P 515283

ON-SITE SEWAGE DISPOSAL SYSTEM HOWARD COUNTY HEALTH DEPARTMENT BUREAU OF ENVIRONMENTAL HEALTH

SUBDIVISION: Cherry Brae

WALL CHECK
PRESERVATION PARCEL "A"
RESUBDIVISION OF CHERRY BRAE
LOT 4
11925 SIMPSON ROAD
ELECTION DISTRICT No. 5
HOWARD COUNTY, MARYLAND
SCALE: 1" = 200' MAY 2001

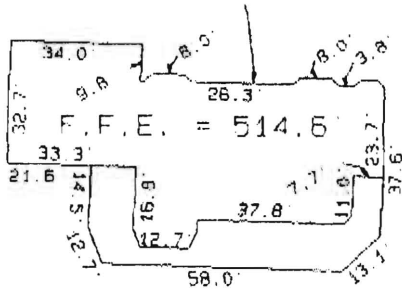
PRE-CONSTRUCTION INSPECTION: boards show site was graded so OK to lay Trenches parallel to

field and set inlet at whatever depth gets into the good nice loam soils. 6/21/01

INSPECTION COMMENTS: Septic Tank set, Baffle installed, House Connection OK, OK to Cover Septic Tank

6/22/01 OK TO COVER ALL (MR)

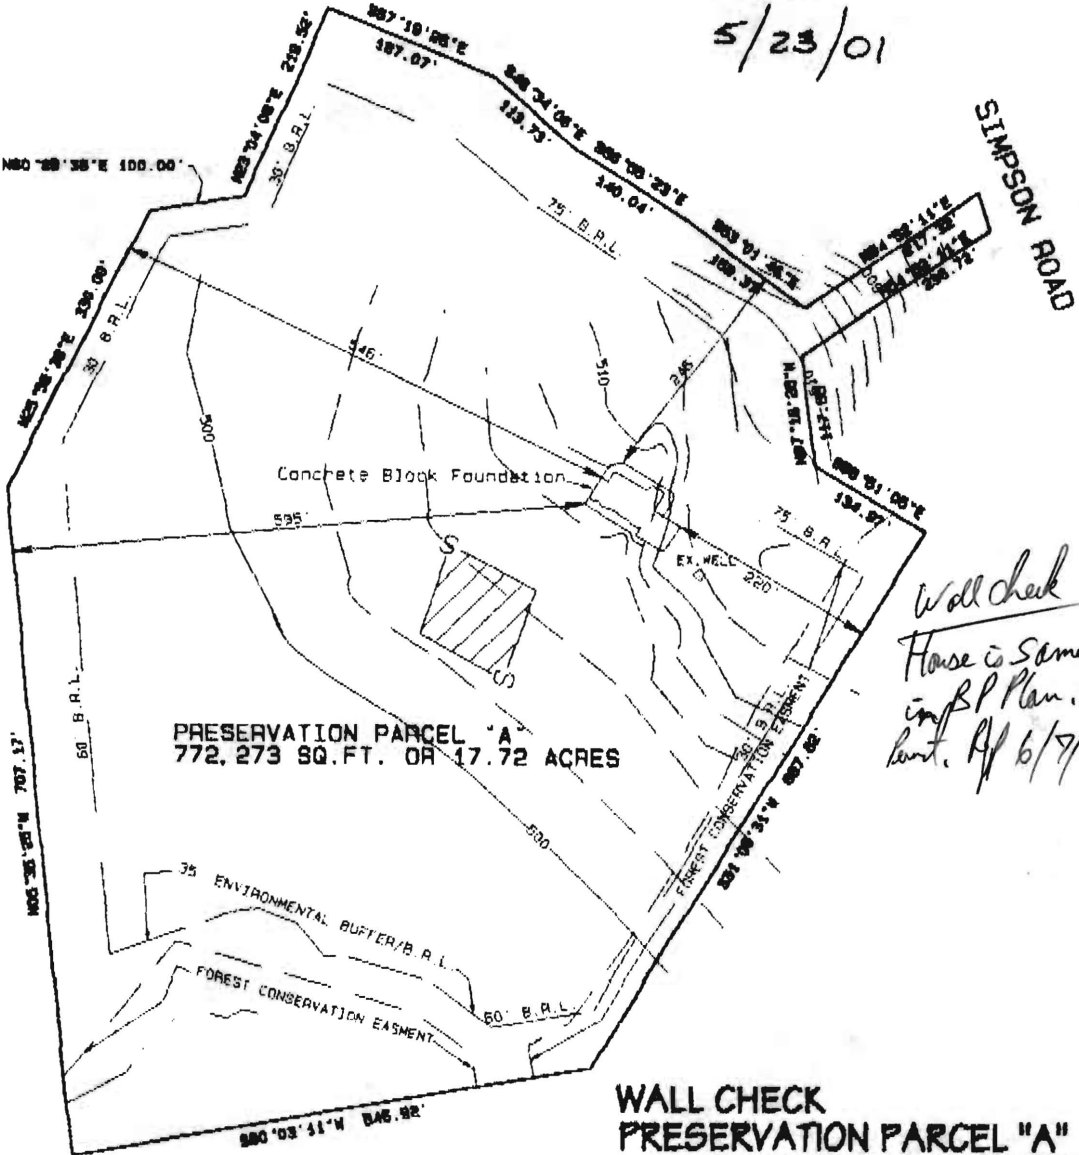
Wall check
House is same as
in P.P. Plan. OK to be
built. Rf 6/7/01

Note: Foundation and footings are in place.
